Service Manual

Amplifier SE-HD70

- Notes:**
- This simplified service manual is provided to indicate the main differences between the original model No. SE-CA01(E) and the subsequent model No. SE-HD70 (E, EB, EG).
 - Refer to the packaging of this service manual.

CHANGES

Cabinet Parts Location (SE-CA01 Service Manual of page 25.)

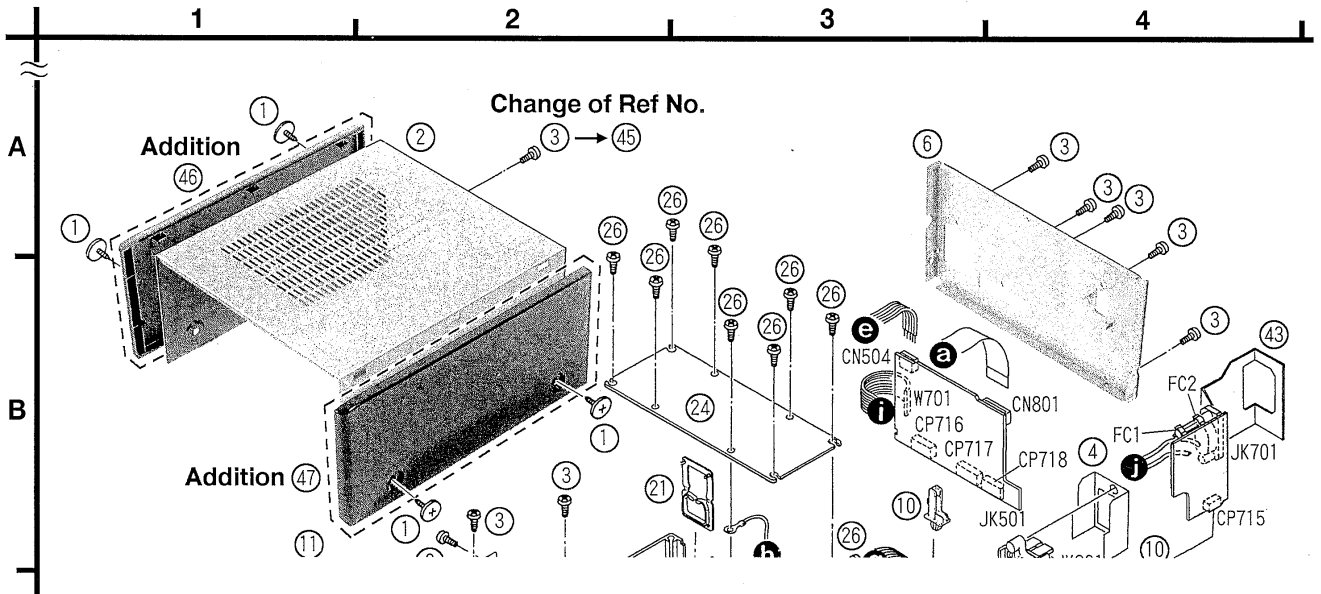
Change in Replacement Parts List (SE-CA01 Service Manual of pages 23, 26, 27.)

Ref. No.	Change of Part No.		Part Name & Description	Remarks
	SE-CA01 (E)	SE-HD70 (E, EB, EG)		
COIL(S) AND RESISTORS				
L501	RLQT490K-V	RLQT560K	COIL	[M]
L502	RLQT490K1-V	RLQT560K1	COIL	[M]
L503	RLQT490K-V	RLQT560K	COIL	[M]
L504	RLQT490K1-V	RLQT560K1	COIL	[M]
L505,506	RLQT240K-V	ERD25V0R00V	RESISTOR 1/4W 0 Ω	[M]
TRANSFORMER(S)				
PT701	RTP2M5B010	RTP2M5B011	POWER TRANSFORMER	[M] Δ
CAPACITORS				
C519,520	ECQV1H155JL3	ECQV1H185JL3	50V 1.8 μ F	[M]
C521,522	ECQV1H105JM3	ECQV1H824JM3	50V 0.82 μ F	[M]
C523,524	ECQV1H224JM3	ECKT1H102KB	50V 1000pF	[M]
CABINET AND CHASSIS				
1	RHD30007-S	RHD30073-K	SCREW	[M]
2	RKM0326C-S	RKM0326A-S	CABINET	[M]
6	RGR0241A-C1	RGR0241A-H	REAR PANEL	[M] (E, EG)
		RGR0241A-K	REAR PANEL	[M] (EB)
29	RFKGCA01E-N	RFKGEHD70E-N	FRONT PANEL ASS'Y	[M]
30	RGK0812-S	RGK0810-N	SIDE ORNAMENT (L)	[M]
31	RGK0813-S	RGK0811-N	SIDE ORNAMENT (R)	[M]
45	---	XTB3+10JFZ1	SCREW	[M] Addition
46	---	RGK0808-M	SIDE PANEL (L)	[M] Addition

47	---	RGK0809-M	SIDE PANEL (R)	[M] Addition
PACKING MATERIAL				
P1	RPG2979	---	---	[M] Deletion
P2	RPG3032	RPG3180	PACKING CASE (AMPLIFIER)	[M]
	RPG3035	---	---	[M] Deletion
	RPG3034	---	---	[M] Deletion
	RPG3033	---	---	[M] Deletion
P3	RPN0971	---	---	[M] Deletion
	RPN0970	RPN0970	CUSHION (AMPLIFIER)	[M]
P4	RPQ0164	RPQ0731	PAD	[M]
P5	RPQ0604	RPQ0738	SPACER	[M]

Packaging (SE-CA01 Service Manual of page 28.)

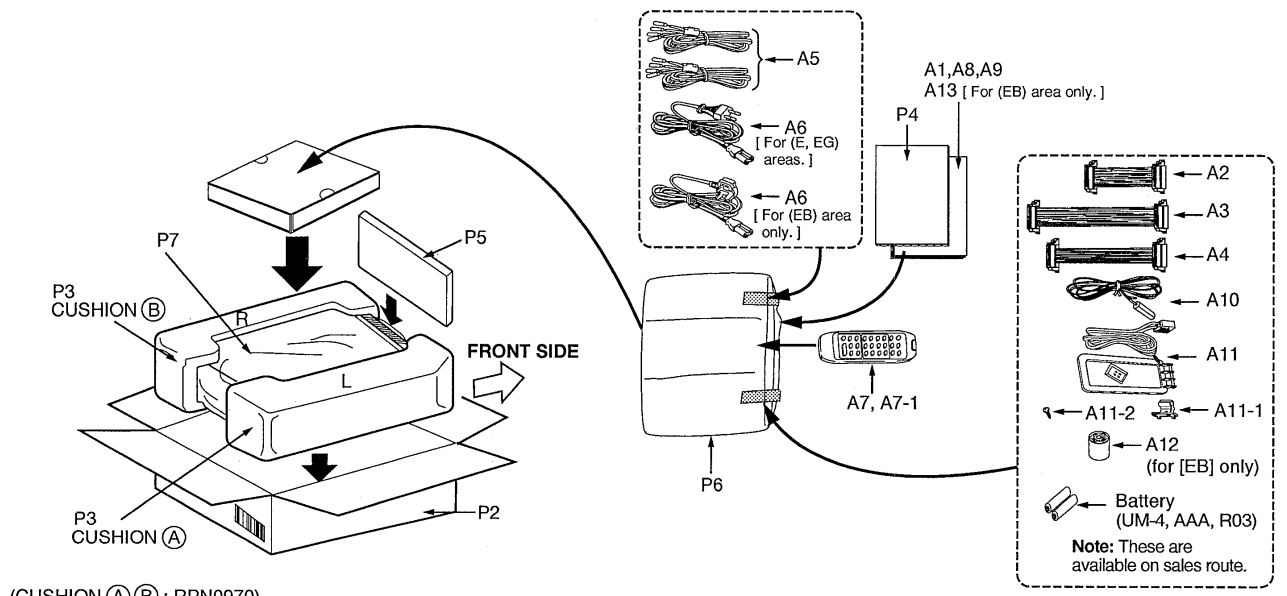
(CUSHION (A),(B) : RPN0970)
